TITLE: GIRDER ~ G2C

JOB: U.S. ROUTE 5 OVER BLACK RIVER  
SPRINGFIELD, VERMONT

WORK ORDER NO. 15713 DRAWING NO. 10-22 REV.

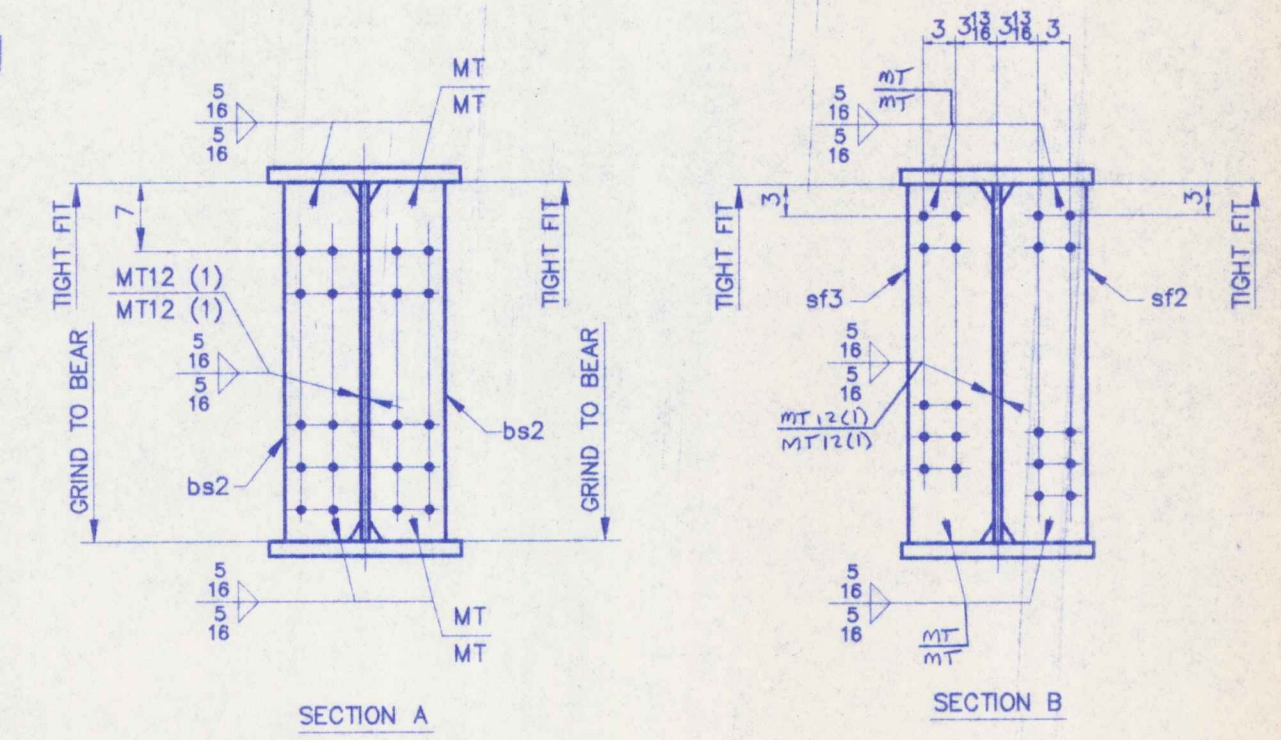
No Exception Taken  Make Corrections Here
